BILL NO. 23-105**ORDINANCE NO. 9702**

AN ORDINANCE APPROVING A PRELIMINARY DEVELOPMENT PLAN ON LAND LOCATED AT 3640 SW ARBORIDGE ROAD IN DISTRICT PMIX, ALL IN ACCORDANCE WITH THE PROVISIONS OF UNIFIED DEVELOPMENT ORDINANCE, CHAPTER 33, OF THE CODE OF ORDINANCES FOR THE CITY OF LEE'S SUMMIT, MISSOURI.

DEVELOPMENT REVIEW FORM TRANSPORTATION IMPACT

DATE: April 7, 2023 CONDUCTED BY: Brad Cooley, PE
SUBMITTAL DATE: October 4, 2022 PHONE: 816.969.1800
APPLICATION #: PL2022314 EMAIL: Brad.Cooley@cityofls.net
PROJECT NAME: ARBORWALK WEST TIA PROJECT TYPE: Prel Dev Plan (PDP)

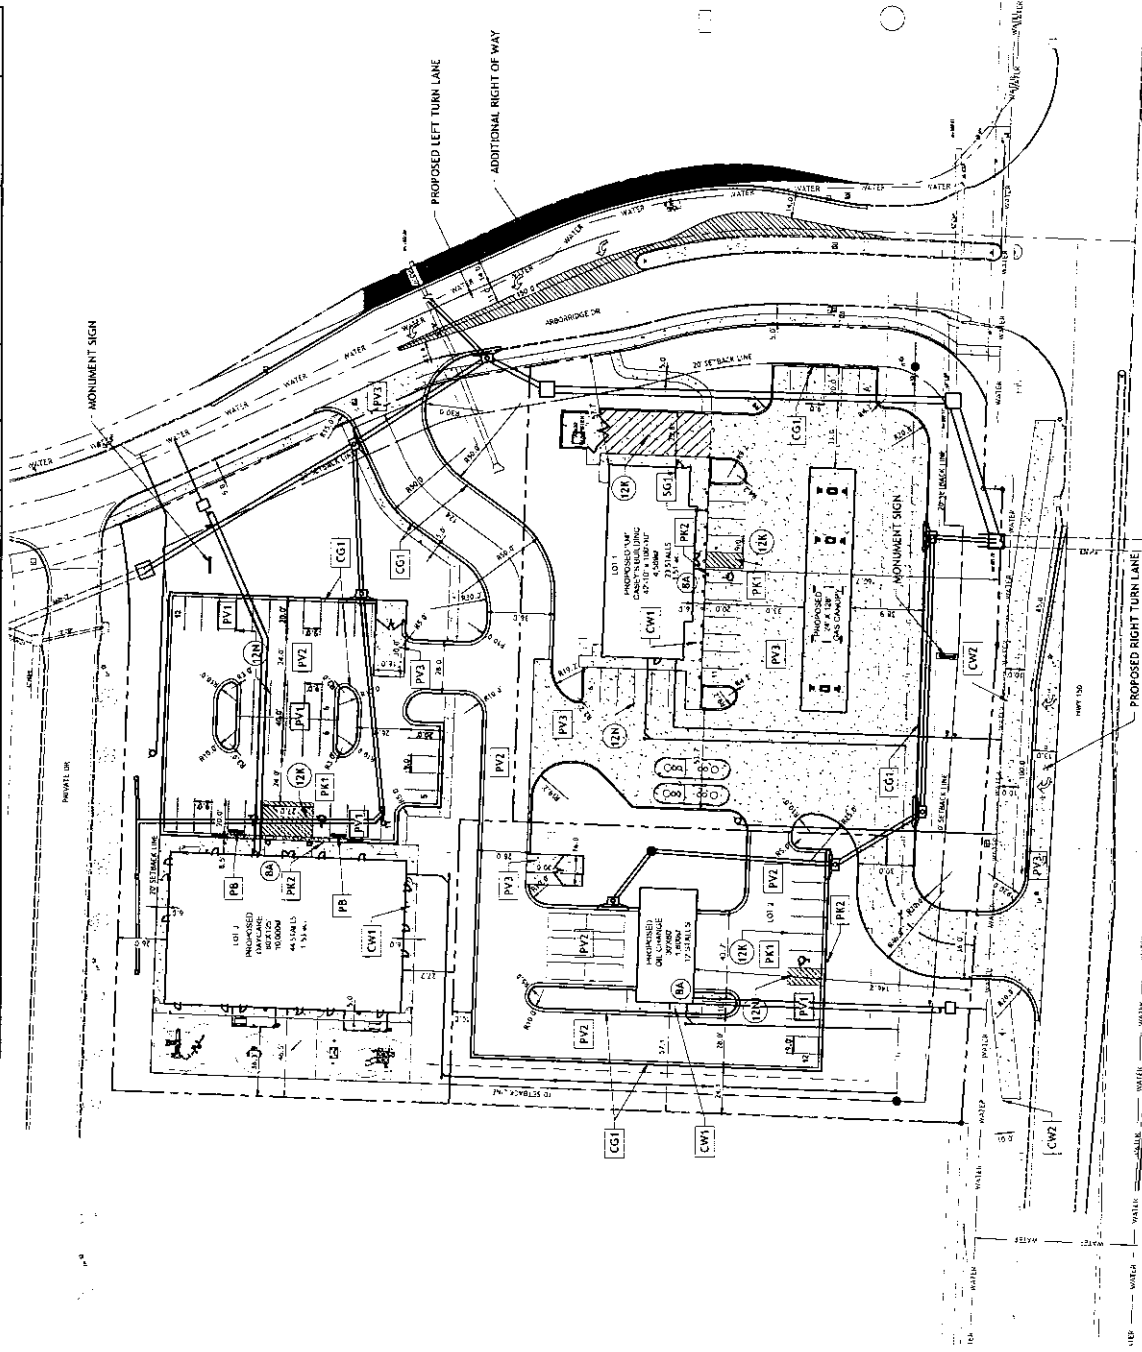
The proposed development has proposed three new access points that do not comply with the City's Access Management Code (AMC). The AMC provides guidance for access spacing in relation to street classification. In addition to spacing between access drives, the AMC provides guidance for upstream and downstream intersection functional area. The intersection functional area sets a distance prior to and following a signalized intersection to keep the intersection itself from becoming congested. Additional analysis is required for turn lane warrants and lengths, per volume and road classification.

The MO 150 access point is located approximately 350' west of Arboridge Dr. and will be a shared right-in-right-out (RIRO) driveway. Per MoDOT's EPG, this access point meets; spacing requirements, driveway width, turn radius, and throat length. The volume expected to utilize this access point does require a right-turn lane, 120' plus 100' taper.

The south access point is planned as a full-access shared drive, approximately 400' north of MO 150. The volume expected to utilize this access point does require a left-turn lane, 150' plus taper. The AMC requires that the taper shall not encroach the intersection functional area and shall be sufficiently separated from the intersection. A full turn lane and taper cannot be constructed to comply with the City's AMC. However, staff believes a shortened taper can be constructed with no safety concerns to the adjacent street. The minimum curb radii shall be widened to comply with commercial collector standards (min. 35').

The north access point will utilize the existing church access drive, which is an existing full-access point on Arboridge Dr., approximately 180' north of the proposed south drive. The volume expected to use the drive does warrant a left-turn lane, 150' plus taper. The proposed connection point to the church's drive provides an approximate throat length of 110' along the church's drive but only provides a 36' throat length on-site. The width of the drive is 24' and does not meet the AMC but does match the drive of the church.

1. A westbound right-turn lane on MO 150 at the proposed RIRO entrance be constructed with a 120' plus 100' taper in compliance with MoDOT's EPG.

2. A northbound left-turn lane be constructed along Arboridge Drive at the south entrance and the existing church drive. The turn lanes shall be 150' plus taper but shall not conflict with spacing requirements or intersection functional area.

3. A traffic signal be installed at the intersection of MO 150 and Arboridge Drive in compliance with MoDOT's EPG.

4. Geometric modification to SW Arboridge Drive associated with the construction of the south entrance. The modifications are necessary to install turn lanes while maintaining required street radii per classification.

5. Extend throat length for north access point to meet City's AMC.

6. Expand the south drive's curb radii to meet the City's AMC.
